**BELLEVILLE COMBINED LICENSE APPLICATION – RESPONSE TO REQUEST FOR
ADDITIONAL INFORMATION – STABILITY OF SUBSURFACE MATERIALS AND
FOUNDATIONS**

Reference: Letter from Ravindra G. Joshi (NRC) to Andrea L. Sturgis (TVA), Request for
Additional Information Letter No. 101 Related to SRP Section 2.5.4 for the
Belleville Units 3 and 4 Combined License Application, dated August 5, 2008

Subject: Stability of Subsurface Materials and Foundations as detailed in the Final Safety Analysis Report

Vertical limits of excavation, Bellefonte Nuclear Plant, Unit 3 (from FSAR Figure 2.5-348a)

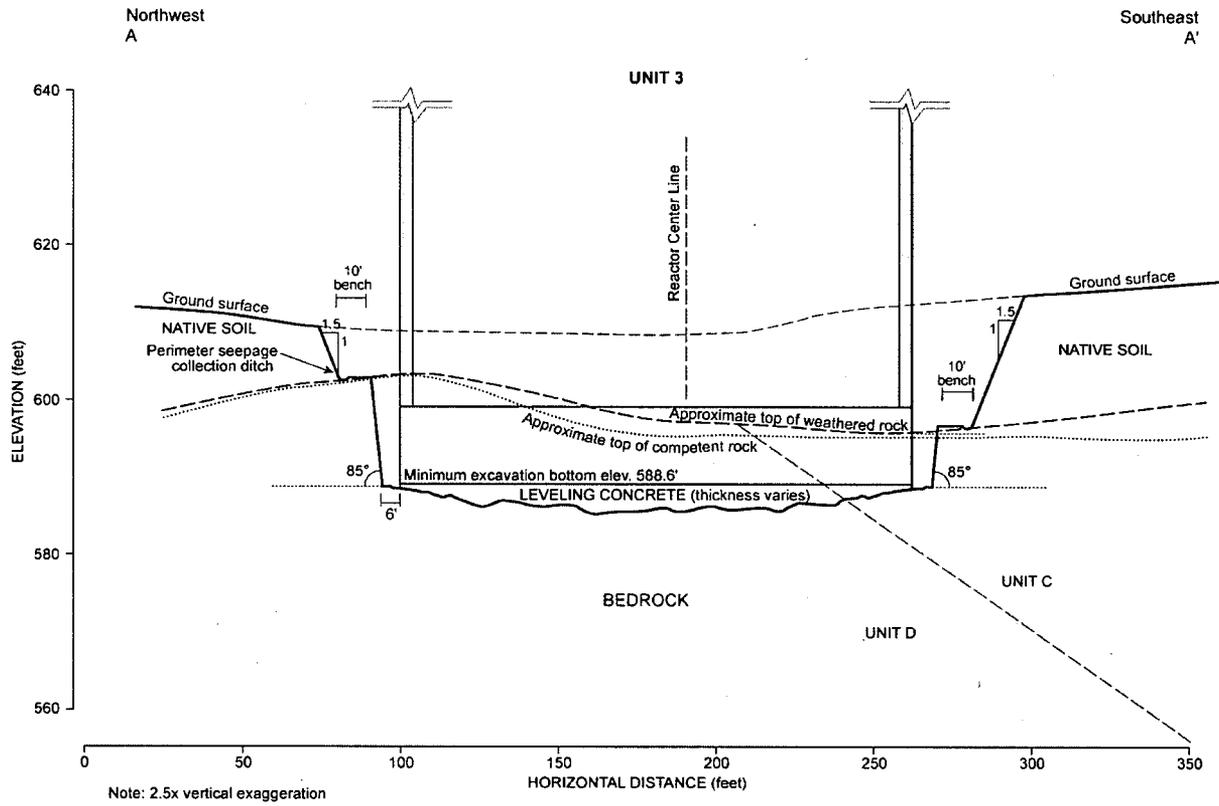
AP1000 DCD (Rev.16) has site criteria for the lateral variability of the foundation supporting soils. Geologic units inside the Middle Stones River Formation demonstrate different geotechnical properties. For example, FSAR Figure 2.5-299 shows a sharp contrast between Units C and D in terms of their shear wave velocities. Due to the inclining layering at the site, different geologic units will appear beneath the same reactor foundation. For example, Middle Stones River Unit C will support the eastern part of the Unit 3 foundation and Unit D will support the western half of the foundation. Please explain if this subsurface lateral variability meets the minimum requirement of the AP 1000 DCD site criteria on lateral variability. Furthermore, please explain if the inclined geologic boundaries beneath the foundation basemat will affect the surface ground motion estimates and possibly introduce a seismic force concentration.

The second part of the question asks if inclined geologic boundaries beneath the foundation basemat will affect the surface ground motion estimates and possibly introduce a seismic force concentration. To answer this question, the potential for surface ground motion amplification associated with lower-velocity Unit C and the fill concrete is first evaluated and then the possibility of a force concentration associated with the inclined geologic boundaries beneath the foundation basemat is evaluated.

The Unit 3 foundation will consist of a relatively thin (1 to 5 ft) layer of leveling concrete emplaced on rock Units C and D (See Figure 1 of Attachment 02.05.04-05A). The leveling concrete will have a shear wave velocity comparable to the lower velocity Unit C which is less than the shear-wave velocity of Unit D.

The Unit 3 foundation velocity structure produced by the dipping strata and the layer of fill concrete consists of two distinct velocities, Unit D with a shear-wave velocity of 10,000 fps, denoted V2, and Unit C and the fill concrete, both with a shear-wave velocity of 6500 fps, denoted V1. This value for V1 is selected to correspond to the lowest plausible mean estimate of V1 consistent with Figure 2 shown in Attachment 02.05.04-05A to obtain the most conservative estimate of the potential influence of V1 on site response and potential seismic force concentrations. These distinct shear-wave velocity regions always have the lower velocity material, V1, located above the higher velocity material, V2. Separating the two velocity units is a nearly flat interface between Unit D and the fill concrete under the western portion of the Unit 3 foundation and a 15 degree east-dipping interface between Units C and D beneath the eastern part of the Unit 3 foundation (shown in Figure 1 of Attachment 02.05.04-05A).

The maximum combined thickness of Unit C and the fill concrete between the basemat and Unit D at the eastern limit of the basemat is about $h=12$ ft. (see Figure 1 of Attachment 02.05.04-05A). The minimum resonance frequency associated with amplification occurs at the eastern limit of the basemat corresponding to the maximum value of h . The minimum resonance frequency associated with amplification is $f=V1/(4*h)=135$ Hz, using the quarter wavelength approximation (Boore and Brown, 1998; eqns. 2 and 5)(Reference 1). Consequently, any amplification associated with the lower-velocity Unit C portion of the basemat will occur at frequencies greater than 100 Hz, which exceeds the maximum frequency considered in probabilistic seismic hazard analyses (NRC Regulatory Guide 1.208, Page 7, last paragraph).

The velocity structure beneath Unit 3 approximates a plano-concave lens that diverges collimated incident waves, in this case incident SH-waves. The qualitative effect of the dipping strata beneath Unit 3 is to defocus seismic forces in the foundation basemat where the dipping interface intersects the fill concrete. The velocity structure does not produce a convergence (focusing) of seismic forces in any other portion of the foundation. Snell's law is used to demonstrate that ray divergence in the fill concrete and Unit C near the intersection of the dipping interface with the fill concrete is never less than 5.3 degrees for the angles of incidence associated with incident shear waves (Figures 3 and 4 of Attachment 02.05.04-05A). The only systematic influence of the dipping strata beneath Unit 3 is to locally decrease seismic forces in the

Revised Figure 2.5-314, Rev. 1
Elevation Contour Maps of Top of Competent Rock from Borehole Data

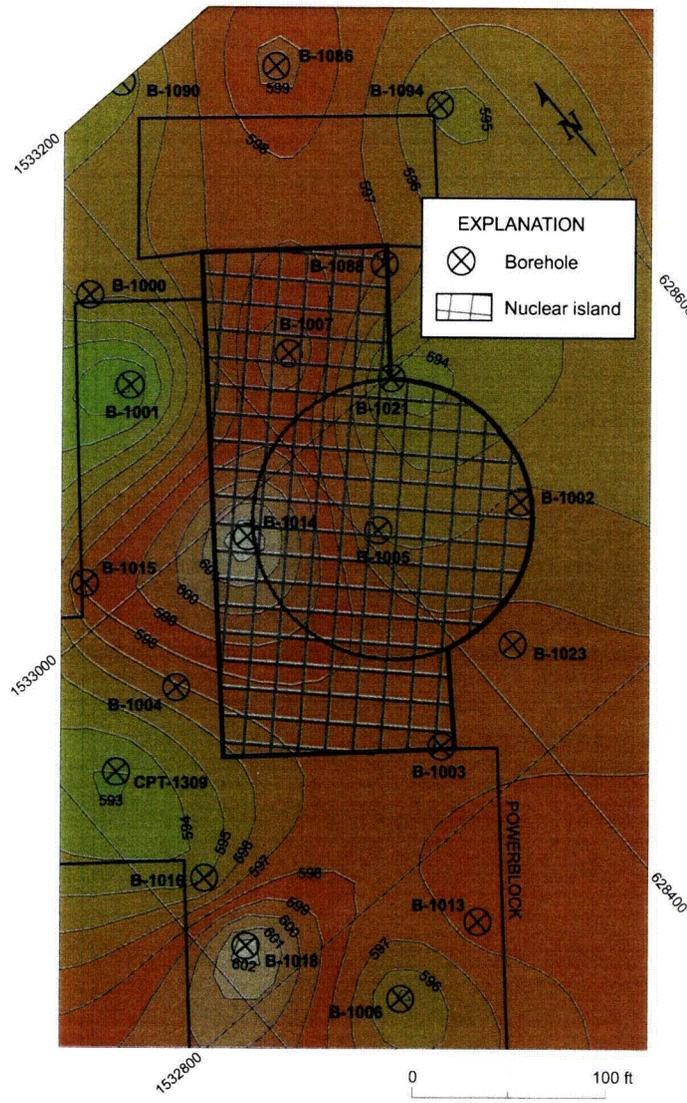
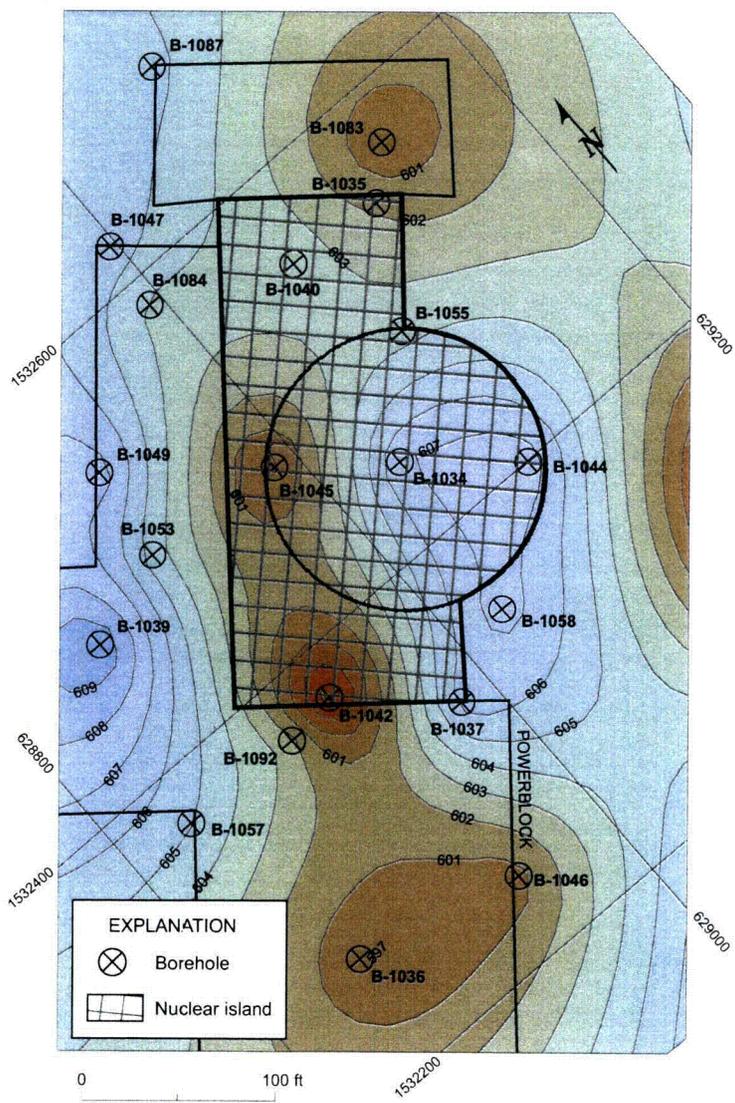
Based on seismic reflection profiles, FSAR Section 2.5.4.1.3.3 presents P-wave velocity (V_p) contours for two surfaces at 6000 and 14000 ft/sec, respectively (in FSAR Figures 2.5-312 and 313). You also implemented P-S suspension logging to measure the P wave velocity profiles at various borehole locations. Please provide a comparison of the wave velocity profiles obtained from these two different methods. Are these methods consistent in terms of P wave velocity measurements? FSAR Figure 2.5-339 shows a site stratigraphic profile across the site, including borehole locations and corresponding shear wave velocity profiles, as well as Units 3 and 4 foundation profiles. The figure demonstrates that the Unit 3 foundation excavation is located inside the bedrock with a shear wave velocity about 9000 fps and a P wave velocity of about 16000 fps. FSAR Figure 2.5-314, however, shows a large area underneath Unit 3 where the top of the 14000 fps (V_p) layer is below elevation 588.6 ft. Please explain the discrepancy.

The discrepancy between estimates to top of competent rock defined by the depth to a P-wave velocity of 14,000 fps based on seismic refraction measurements in FSAR Figure 2.5-314 and the estimates of depth to top of competent rock defined in FSAR Figure 2.5-339 based on borehole data are the results of several systematic factors in the acquisition, analysis, and interpretation of the seismic refraction data that tend to introduce a bias to overestimate refractor depths.

The cumulative effects of all refractor depth estimation biases is sufficient to explain the tendency of Figure 2.5-314, based on seismic refraction analyses of depth to refractor, to overestimate depths to top of rock by 0-20 ft relative to FSAR Figure 2.5-339, which is based on borehole data. Consequently, the most appropriate definition of depth to competent rock should be based on borehole data and actual conditions revealed during excavation, not on the seismic refraction data.

4. COLA Part 2, FSAR Chapter 2, Figure 2.5-314 will be revised as presented in Attachment 02.05.04-06A.

Revised Figure 2.5.4-360

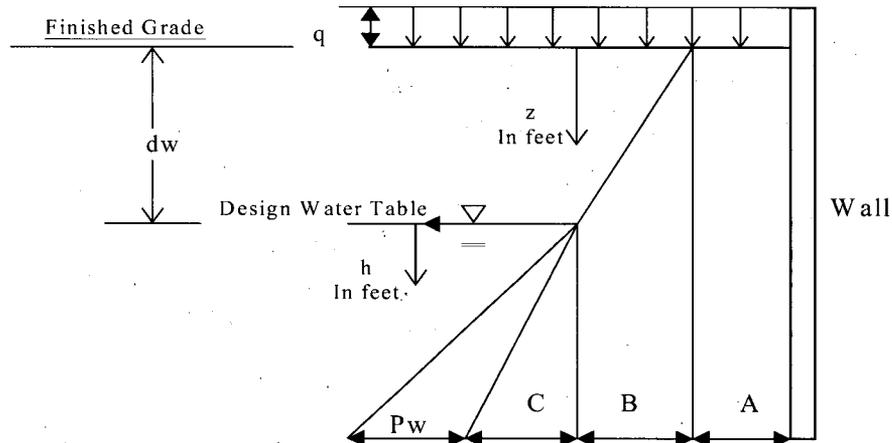
FSAR Section 2.5.4.10.5 states that the earth pressure coefficients for the at-rest and passive conditions determined using the methods described in Reference 462 are illustrated in FSAR Figures 2.5-360 and 2.5-361. FSAR Figure 2.5-360 shows the distribution of earth pressures from the soil backfill (at-rest condition), and, below the water table, the additional pressure caused by the hydrostatic pressure. FSAR Figure 2.5-361 shows the soil passive pressure distribution. No hydrostatic pressure is included in the passive pressure because water has no shear strength and provides no additional passive resistance. Since the hydrostatic associated pressure also contributes to the lateral pressure applied to the nuclear island walls, excluding the hydrostatic pressure from the passive, at-rest, or active earth pressure evaluation is not justified. Please include the hydrostatic pressure into passive or at-rest earth pressure evaluation and revise the contents of FSAR Figs. 2.5-360 and 2.5-361, accordingly.

Discussions with NRC technical staff have clarified that inclusion of the hydrostatic pressure in the at-rest and passive earth pressure diagrams is appropriate for the nuclear island basement walls. The FSAR text and Figures 2.5.4-360 and 2.5.4-361 will be revised as described below in a future revision of the COLA.

Earth pressure coefficients for the at-rest and passive conditions determined using the methods described in Reference 462 are illustrated in Figures 2.5-360 and 2.5-361. Figure 2.5-360 shows the distribution of earth pressure from the soil backfill (at-rest condition), and, below the water table, the additional pressure caused by hydrostatic pressure. Figure 2.5-361 shows the soil passive earth pressure distribution, including the additional pressure caused by hydrostatic pressure below the water table.

2. COLA Part 2, FSAR Chapter 2, Figure 2.5.4-360 will be revised as indicated in Attachment 02.05.04-21A.
